No. EC120-53-019

SERVICE BULLETIN

**DOORS - Panel of communication
Improvement on the attachment and sealing of the panel of
communication cabin-cargo**

Revision No.	Date of issue
Revision 0	2023-05-12

Figure 1

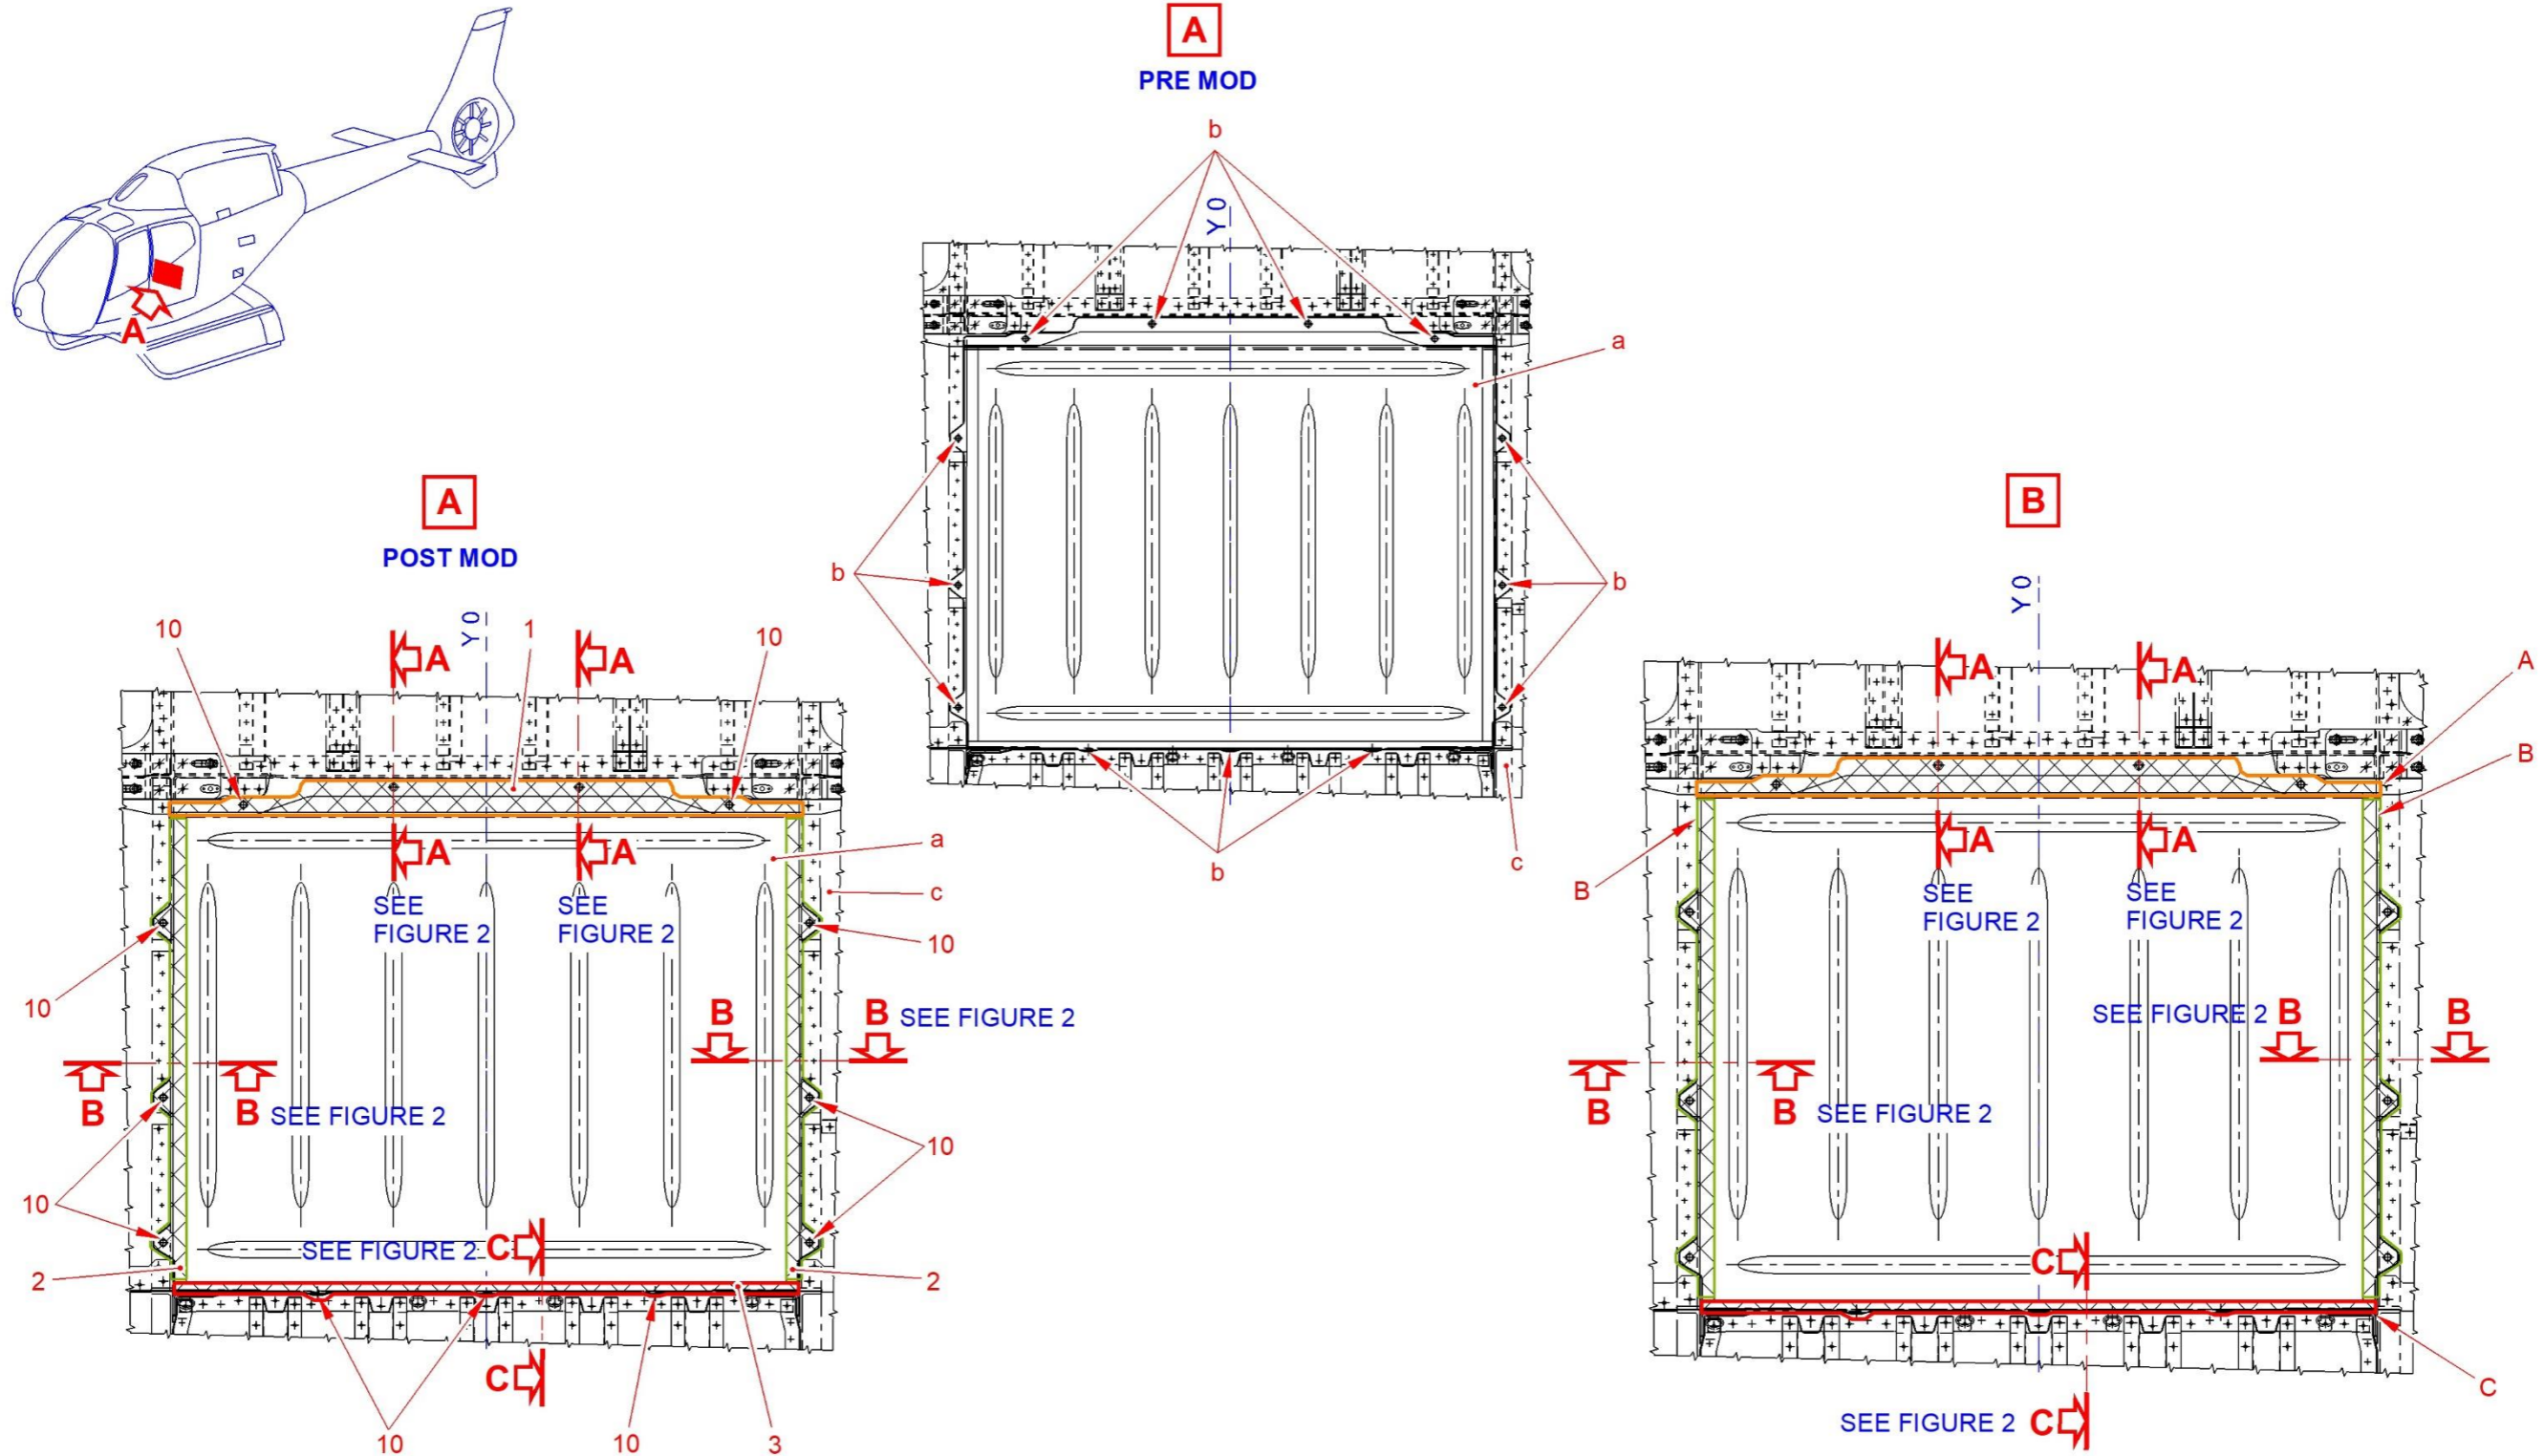
- Remove the panel of communication cabin-cargo (a) and the clips (b) from the cabin bulkhead (c) (Detail A - PRE MOD).
- Discard the clips (b).

On the panel of communication cabin-cargo (a) ([Figure 1](#), Detail A - POST MOD):

- Put in position:
 - . The upper joint (1)
 - . The lateral joints (2)
 - . The lower joint (3).
- To avoid collision with the optional folding litter MP/N C255A3201051 (if installed), cut the lateral joints (2).
- In accordance with the joints (Detail B), identify with marks, strip and clean:
 - . The area (A)
 - . The areas (B)
 - . The area (C).
- Use the adhesive (4) to install:
 - . The upper joint (1) (Figure 2, SECTION A-A)
 - . The lateral joints (2) (SECTION B-B)
 - . The lower joint (3) (SECTION C-C).
- Let the adhesive (4) dry.
- Install the quick fastener (8) and washer retaining (9).

Figure 2

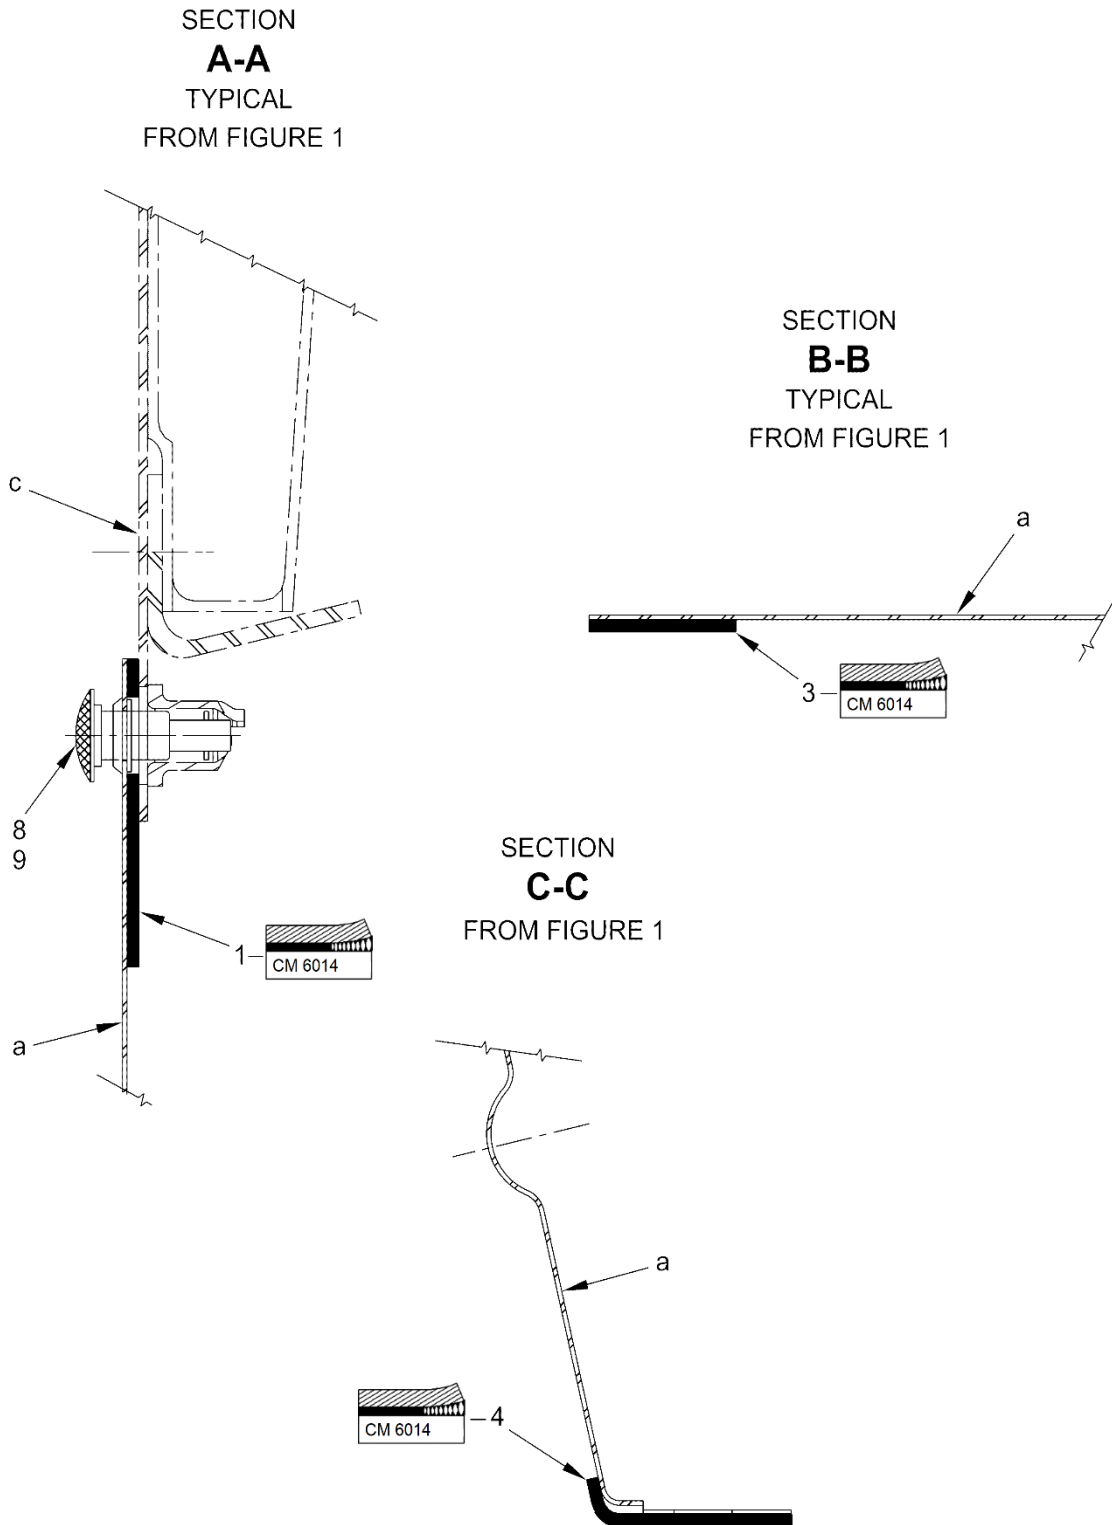
Install the panel of communication cabin-cargo (a) on the cabin bulkhead (c) with the clips (10).

Figure 3

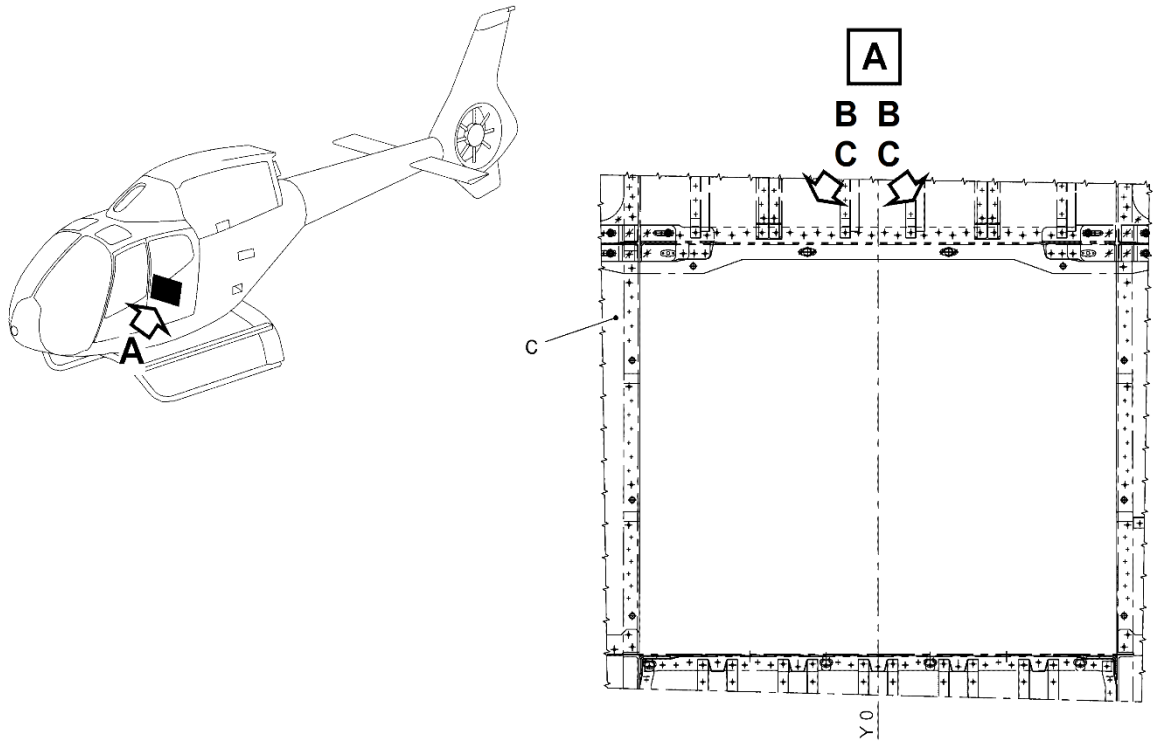
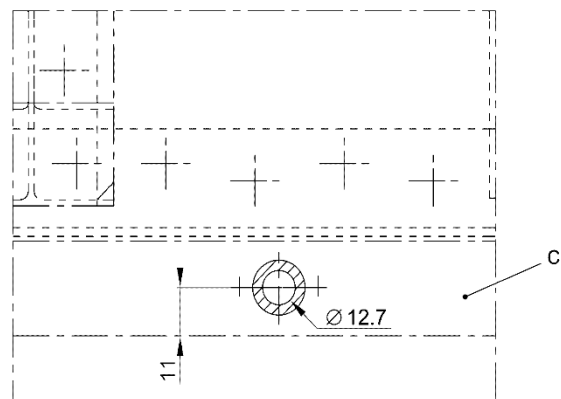
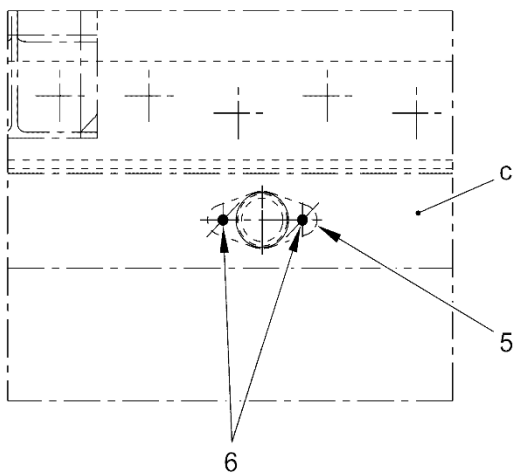
- Increase the existing boreholes on the cabin bulkhead (c) with a drill bit diameter 12.7 mm ([Figure 3](#) - Detail B).
- Clean the work areas.
- Put in position the quick fastener sockets (5) on the cabin bulkhead (c) ([Figure 3](#) - Detail C).
- Counter drill the 4 rivet holes from the quick fastener sockets (5) to the cabin bulkhead (c) with a drill bit diameter 2.5 mm.
- Remove the quick fastener sockets (5) from the cabin bulkhead (c).
- Clean the work areas.
- Apply touch-up pen (7) (not shown) on the boreholes.
- Apply Basic resin for primer (11) (not shown). Refer to Work Card 20-04-05-402 (MTC).
- Install the quick fastener sockets (5) to the cabin bulkhead (c) with 4 countersunk rivets (6). Refer to Work Card 20-03-02-401 (MTC).
